## Clarksburg Road – Snowden Farm Parkway (CIP Project No. 508000-03), Mandatory Referral No. MR201818

#### **Mandatory Referral MR2018018: Clarksburg Road – Snowden Farm Parkway**

### MEMORANDUM

**REVIEW TYPE:** Mandatory Referral No. MR2018018

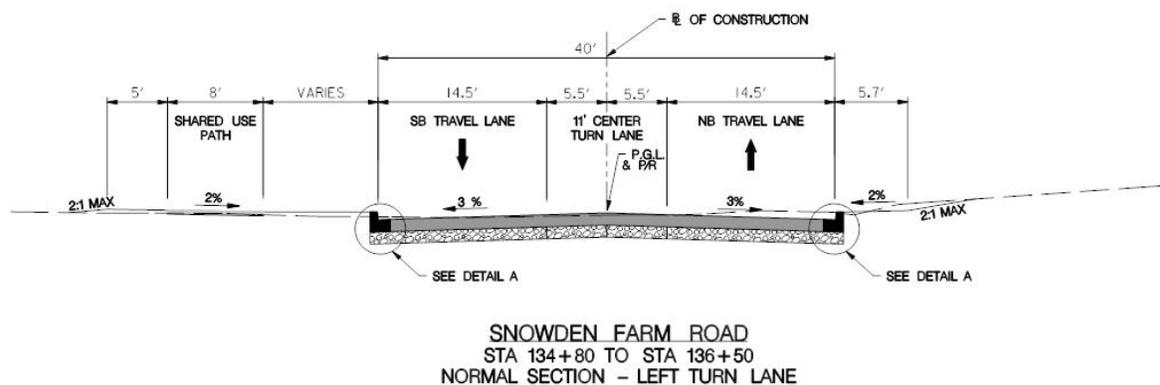
The proposed typical section along Clarksburg Road is generally consistent with the typical section proposed for the MCDOT Clarksburg Road at MD 355 Intersection Improvement project (also CIP Project No. 508000-09), which is just south of the subject project. The proposed travel lane widths are 10-foot wide which is in accordance with the requirement for urban roads in the County Council's Expedited Bill 33-13 (Streets and Roads Urban Road Standards and Pedestrian Safety Improvements).

The proposed sidepath width is 8-foot wide, which is the minimum sidepath width in environmentally sensitive areas per the County Council's Expedited Bill 33-13. This use of minimum width ties into the existing and proposed 8-foot wide sidepath along eastbound Snowden Farm Parkway. The one

discrepancy between this project and the adjacent CIP project is that the project to the south proposes a 10-foot wide sidepath.

The proposed center two-way left-turn lane allows cars to turn left without disrupting the flow of traffic at Overlook Park Drive/Catawba Manor Way, and Windsong Lane. The center two-way left-turn lane will also transition into an exclusive left-turn lane at the Snowden Farm intersection, consistent with the recommended typical section in the 2014 Clarksburg Ten-Mile Creek Master Plan Limited Amendment.

While we initially were concerned about the need for a continuous center two-way left-turn lane along this road, this is a consistent cross section with the section of Clarksburg Road to the south (between Frederick Road and Overlook Park Drive). The turn lane will allow access to Overlook Park Drive, Windsong Lane, the King's Local Park parking lot and Snowden Farm Parkway. There is a case to be made for maintaining continuity when left-turn needs are closely spaced. With four left-turn opportunities over a distance of 1,600 feet, this equates to 400 feet per left-turn location.

# Signing and Marking Plans (Sheet SN-2.3)

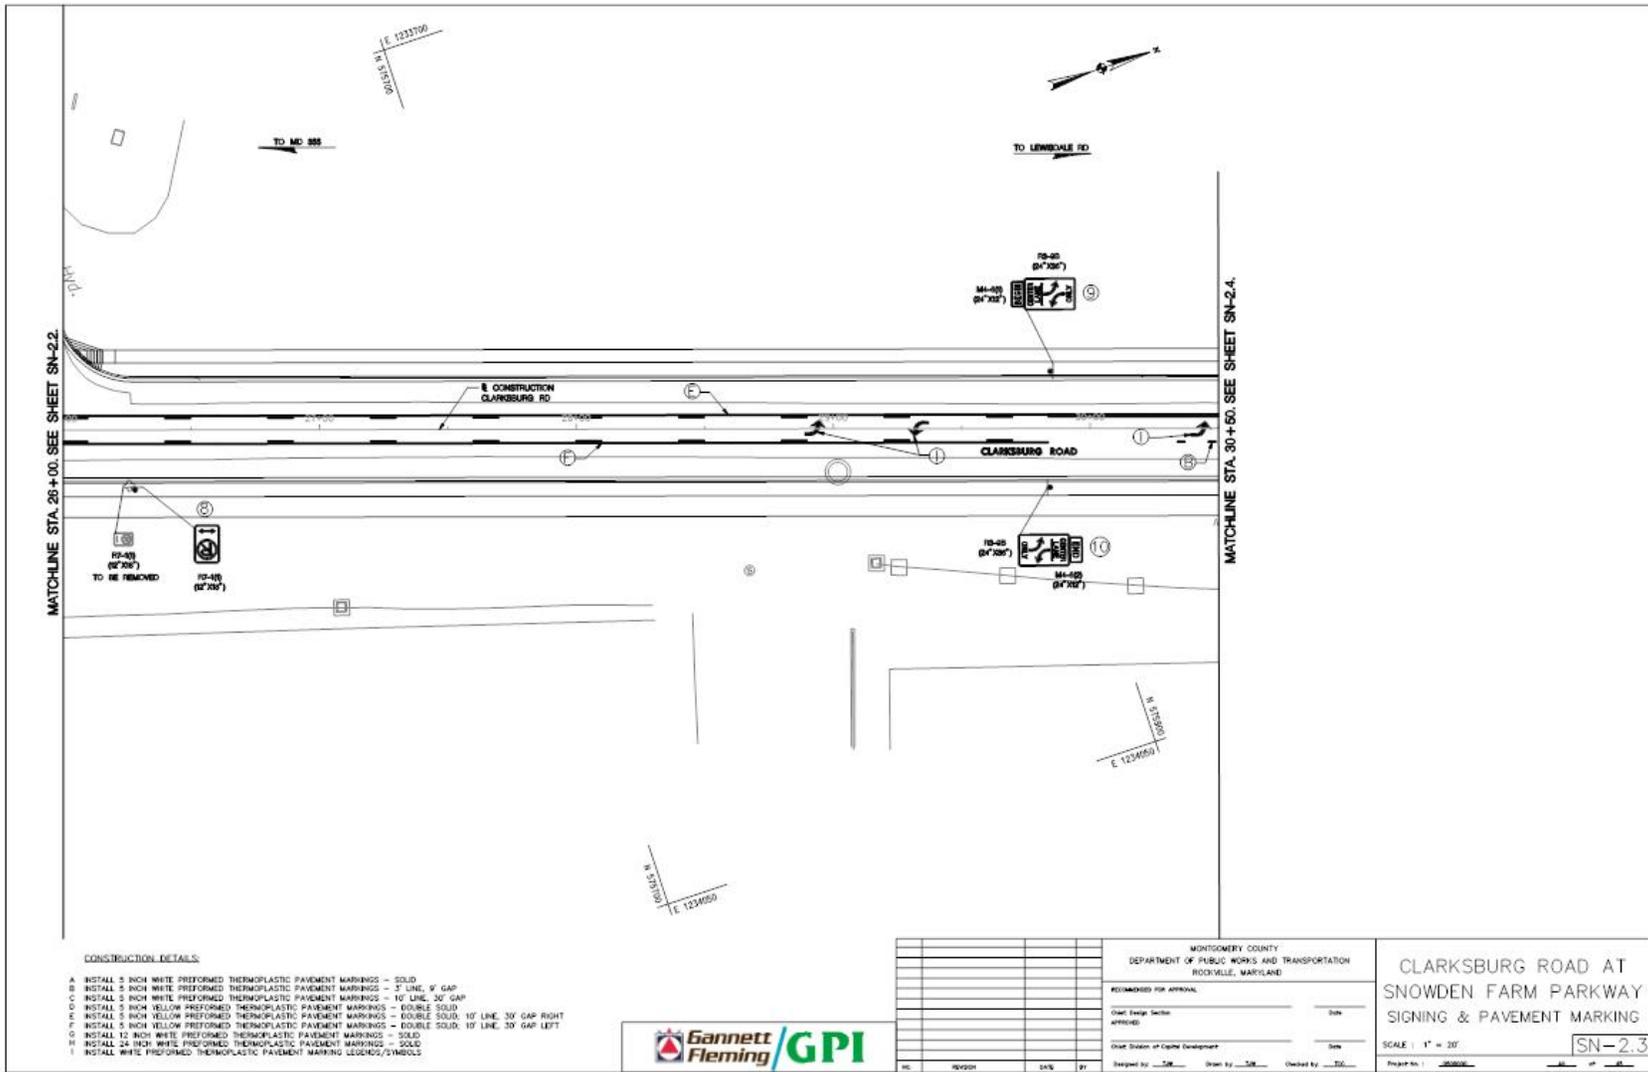
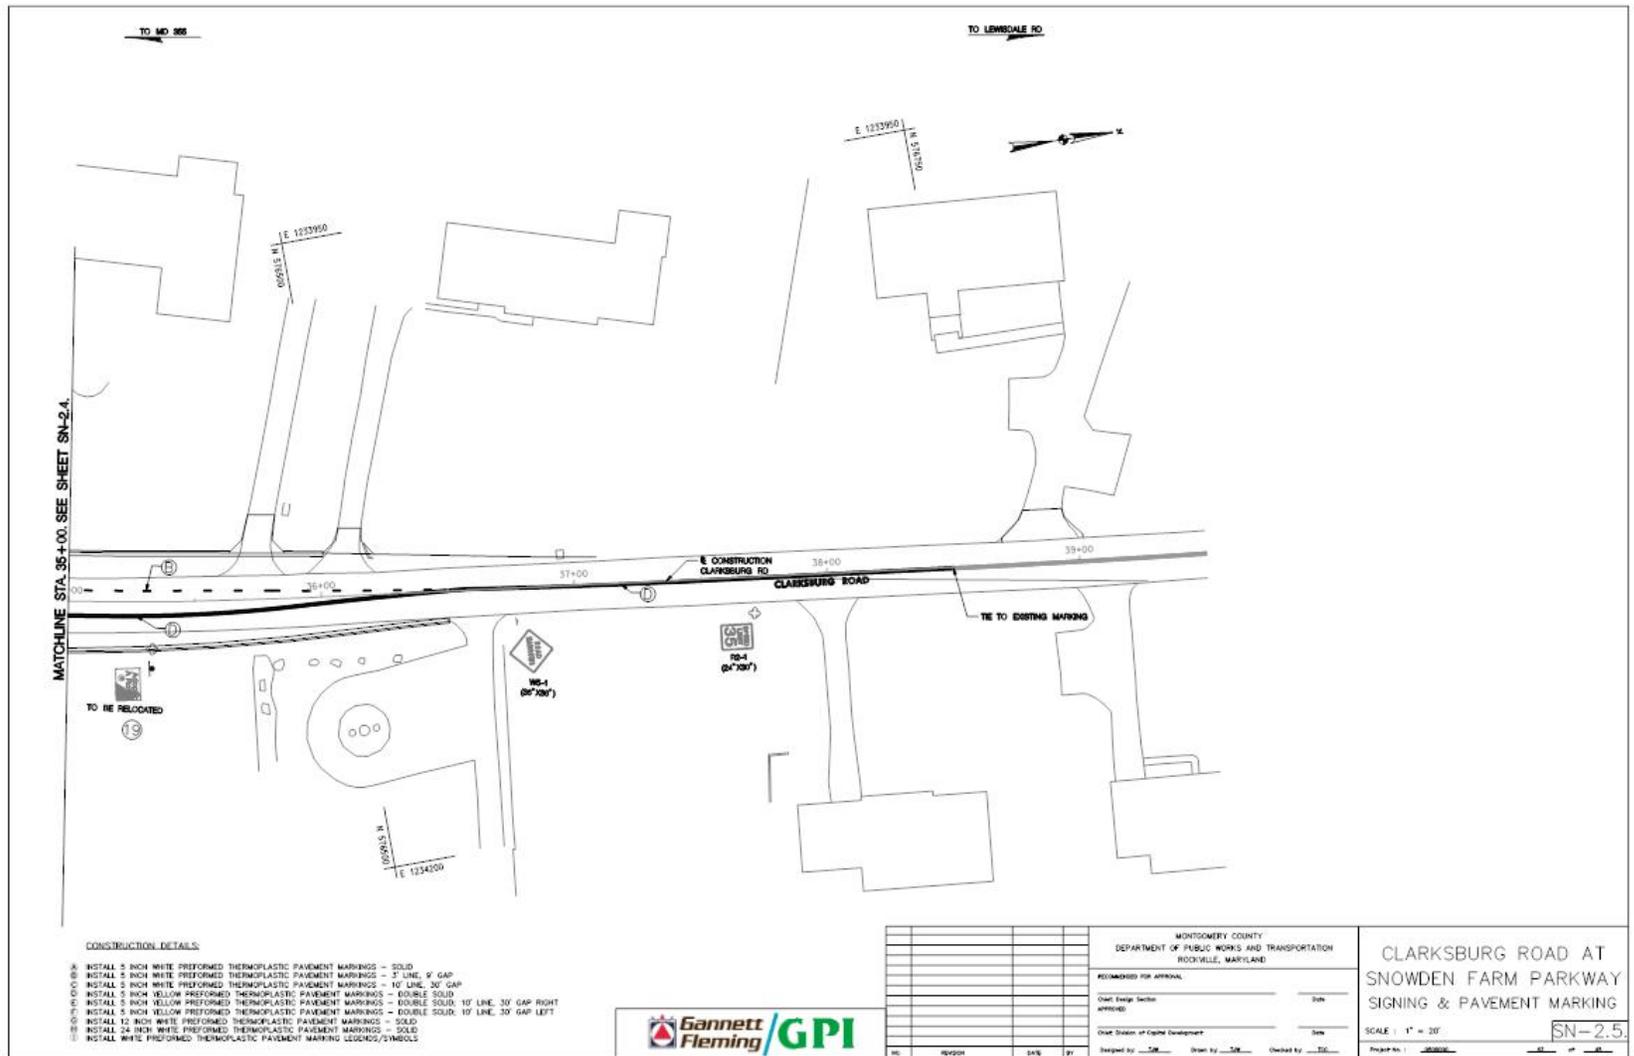
9. A crosswalk should be added to this project across Clarksburg Road on the north side of the Windsong Lane intersection. A pedestrian refuge island should be considered in the center turn lane.

10. A crosswalk should be added to this project across Clarksburg Road at the intersection of Overlook Park Drive/Catawba Manor Way.

Figure 2. Clarksburg Road at Snowden Farm Parkway Project Vicinity Map

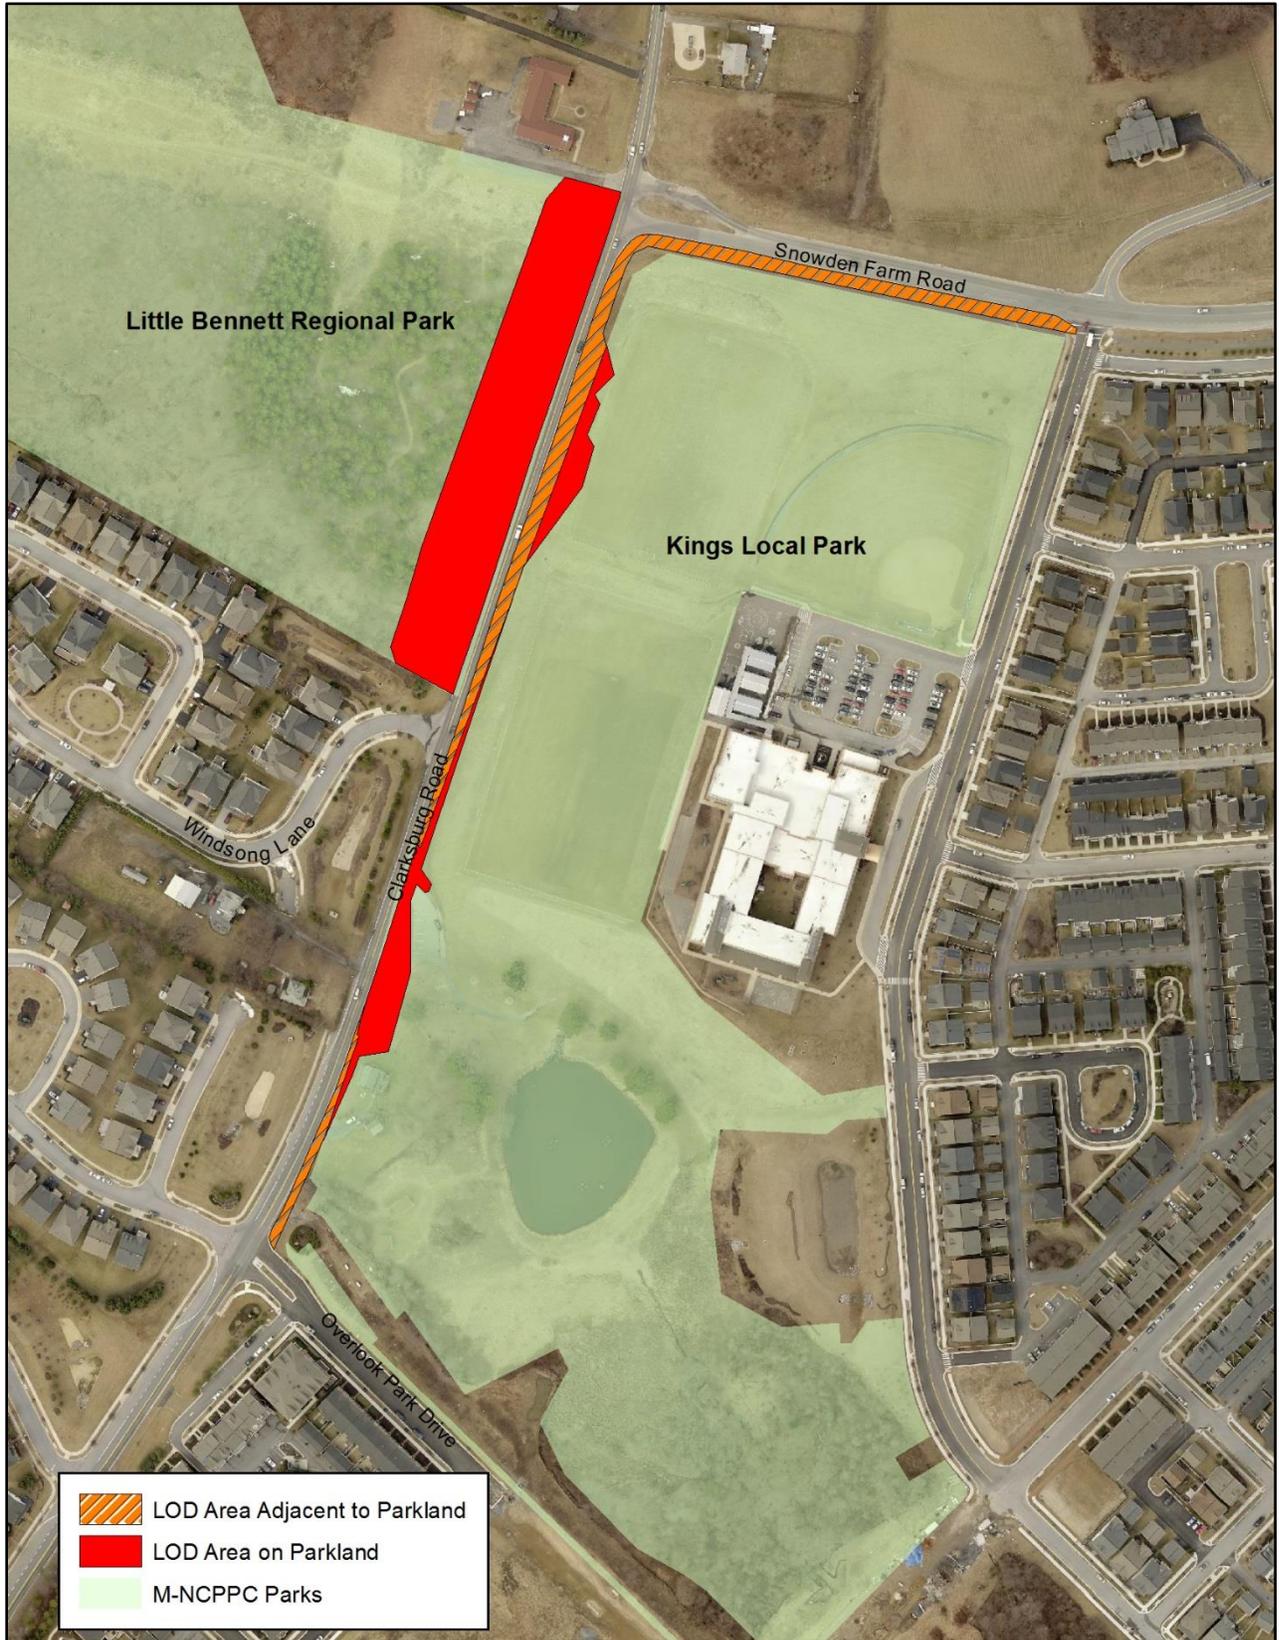
There is a small ROW expansion proposed on the east side of the road adjacent to the athletic fields towards an existing mowed grass swale. The current plan proposes to create a 2:1 slope (occasionally steeper) for the swale in this area. The Department of Parks requires 3:1 maximum slopes so that the swale area can be safely mowed. The contours shown on the plan need to be extended towards the athletic field area for park maintenance and operations to continue.

The most significant expansion of ROW onto parkland has been proposed on the west side of Clarksburg Road. An area of approximately 50,000 square feet has been proposed to be used for four bioretention stormwater management facilities. This area is primarily early successional habitat composed of cedars, red maple, ash, locust, cherry and walnut trees. The most significant tree is a 40" DBH catalpa that is proposed to be removed for the proposed stormwater management facilities. MCDOT wants to consolidate the stormwater management to one location by oversizing the facilities. Coupled with the existing steep slopes in this area, the bioretention facilities have a very large footprint that measures 80 feet wide. For reference, the MCDOT proposed road

section is only 40 feet wide. The Department of Parks recently acquired the property at 23701 Clarksburg Road and there is now potential to provide treatment for this previously bypassed impervious area. MCDOT must evaluate the potential to locate stormwater management facilities on this newly acquired property to confirm the suitability for Environmental Site Design (ESD) strategies. If feasible, this additional stormwater management will alleviate a portion of the impacts the facilities pose in Little Bennett Regional Park. Regardless of these findings, a requirement of the Park Construction Permit will be for MCDOT to work with the Department of Parks to minimize the number and footprint of the bioretention facilities between Windsong Lane and Snowden Farm Parkway to provide adequate treatment of runoff while not unduly impacting existing natural resources. MCDOT will be responsible for all maintenance and operation of the proposed stormwater facilities.

The existing entrance to Kings Local Park is affected by the proposed addition of the shared-use trail and associated grading. Excavation for a stormwater pipe is also proposed in the vicinity of the park entrance. MCDOT will be required rebuild the existing parking lot to at least the original capacity with design assistance from the Department of Parks to ensure that any changes made are consistent with planned Kings Local Park improvements. The parking lot must comply with Americans with Disabilities Act (ADA) guidelines to the maximum extent practical. The parking lot may not be closed to the public during construction unless otherwise negotiated with the Department of Parks prior to construction. Access for Department of Parks' maintenance vehicles will need to be maintained throughout the construction phase.

The acquisition of the property at 23701 Clarksburg Road allows MCDOT to continue the standard roadway and trail section to the intersection at Overlook Park Drive. The current plans show the roadway and trail without adequate buffer and the installation of a retaining wall. The Department of Parks supports the Planning Department's recommendation to provide a minimum six-foot-wide tree buffer between the back of curb and the shared-use path and agrees to provide MCDOT the necessary ROW to continue the typical section through this property.
